**RE: Parking, Curb and Sidewalk Improvement;
Heyward & Marion Streets
For the University of South Carolina
URS Project No. 46422191
State Project No. H27-I985**

ADDENDUM NO. 1 – April 26, 2012

PROJECT PARKING, CURB AND SIDEWALK IMPROVEMENT HEYWARD & MARION STREETS FOR UNIVERSITY OF SOUTH CAROLINA IN THE CITY OF COLUMBIA RICHLAND COUNTY, S.C.	SHEET TITLE IRRIGATION PLAN	DATE: MARCH 23, 2012	SCALE: SCALE=1"=30'
DATE: 3/23/12 PROJECT NO: 34.357-892 FILE NO: 35.803-888

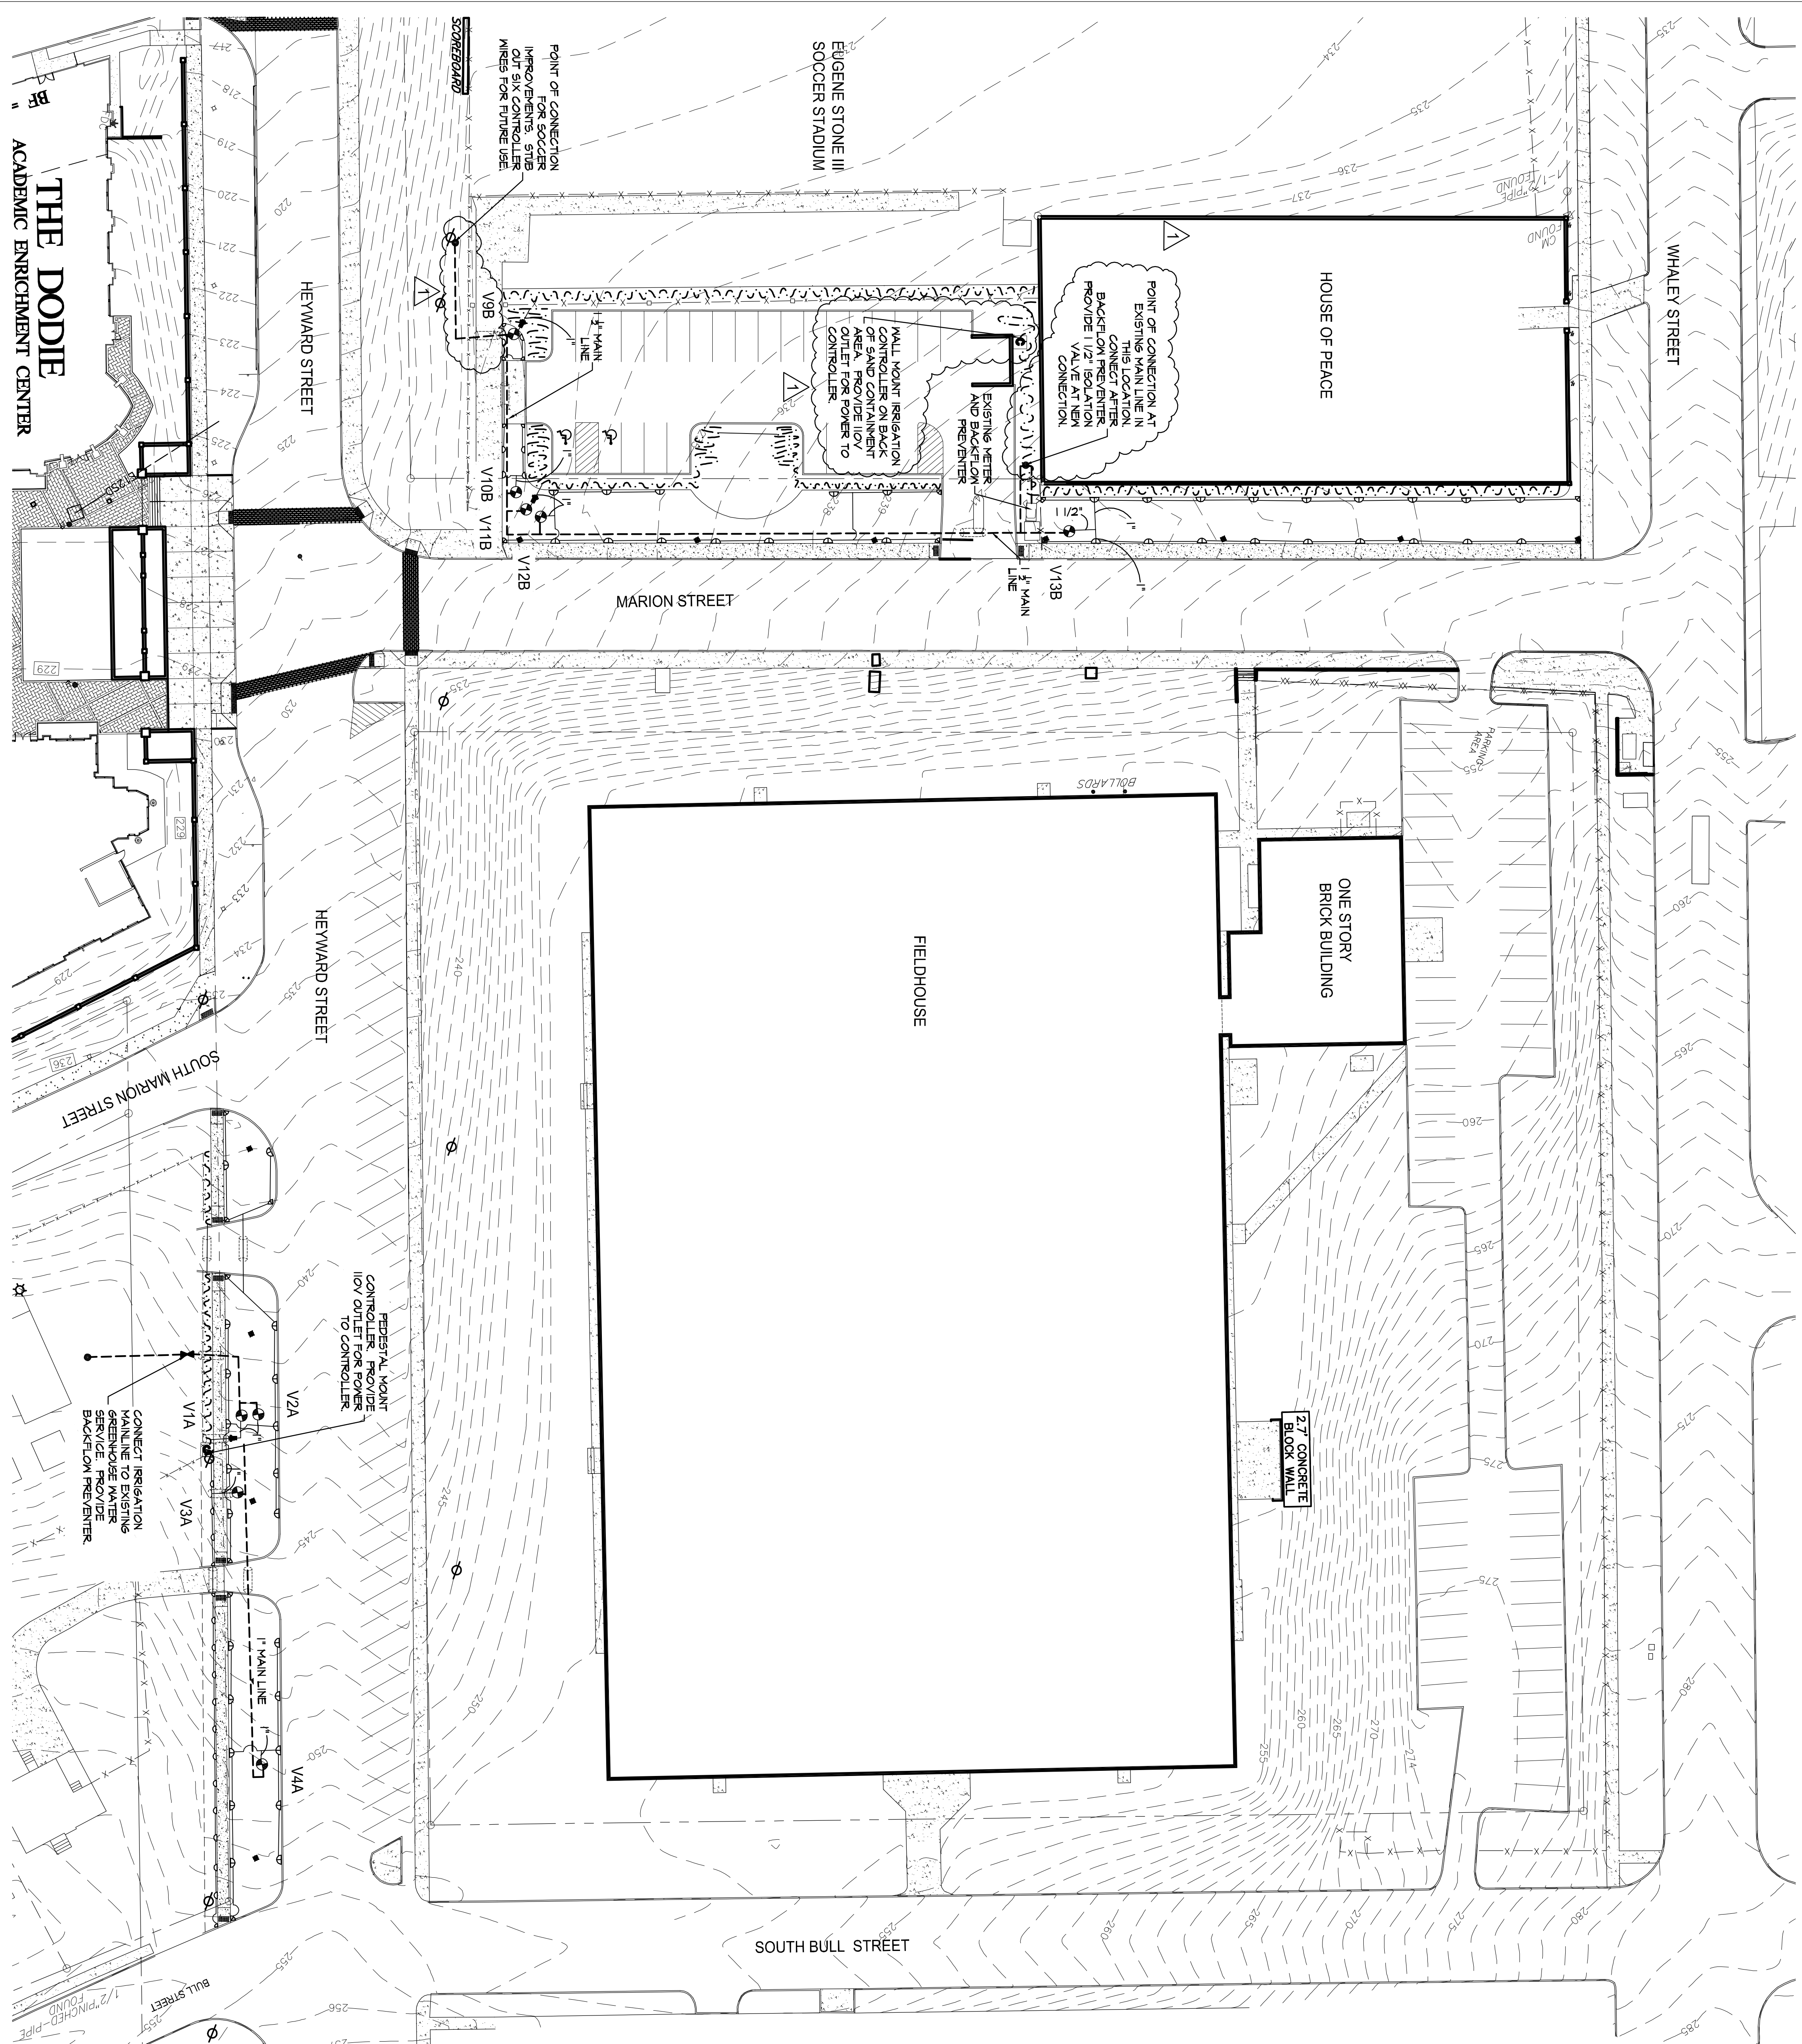
1. L-2 Irrigation Plan: Omit the meter and move the point of connection for the soccer parking lot area as shown on the drawing. Connect just beyond the existing backflow preventer. Move the controller to the back of the sand containment area. Cap off mainline beyond the sidewalk for future use on Heyward Street – Soccer Improvements. Stub out 6 controller wires for future use. Be sure that future wires are connected to the controller.
2. E-1 Electrical Site Plan: Provide receptacle in weather-proof enclosure for the irrigation controller.

APPROVALS	REVISIONS
PROJECT ENG: []	NO. DESCRIPTION DATE BY
DESIGNED BY: []	1 Move Controller, new point of connection, stub out wiring for soccer project. 4.24.12 SKC
DRAWN BY: []	
CHECKED BY: []	
APPROVED: []
